Items for Discussion

Eric James
FD1 Technical Board
April 10, 2024

Increasing Gap between APAs in Doublet

Figure 4: The nominal gap between the APAs

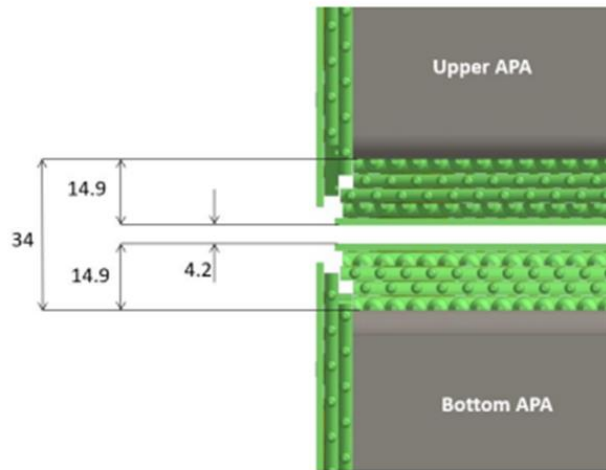
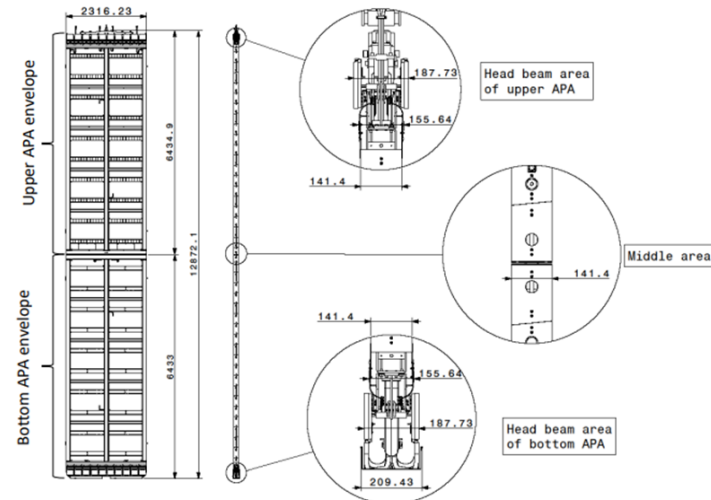
- The baseline nominal gap between two APAs in an APA Pair is 34mm (as shown in the left-hand image)
- A proposal was made to increase this value by 6mm

Figure 5: The worst case of vertical interference between top and bottom APA

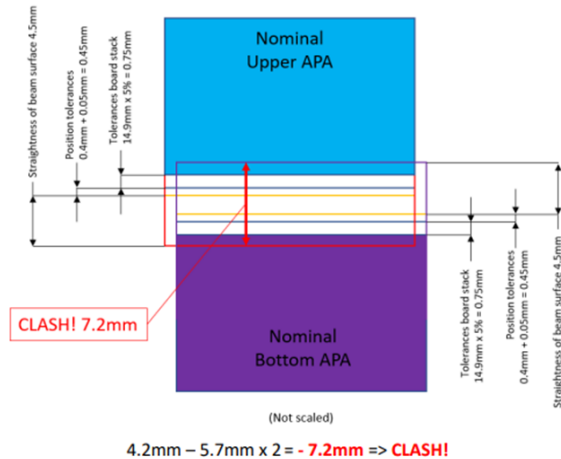
- One of the DUNE requirements for individual frame members is straightness of +/-4.5mm, regardless of length
- Thickness tolerance of circuit boards is 5%
- Using these two criteria, the baseline nominal gap (of ~4mm) is insufficient.

The worst case of vertical interference between top and bottom APA shown in Figure 5.

Implementation

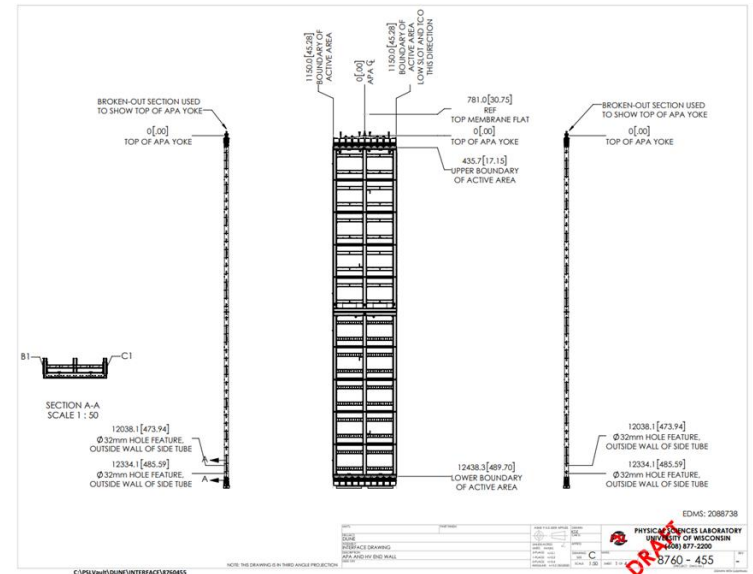
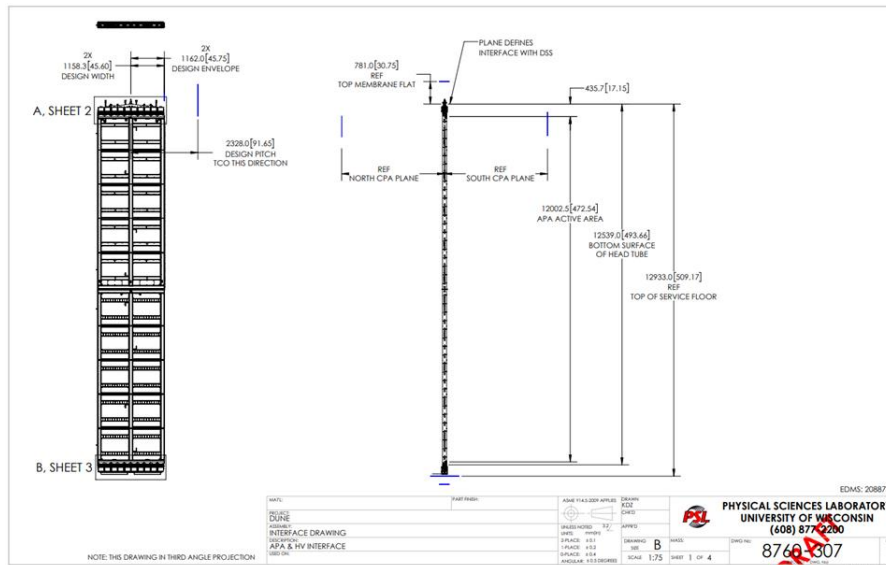
- The proposed method is to increase the gap by 6mm by lowering the bottom APA
- HVS consortium has nominally signed-off on this proposal
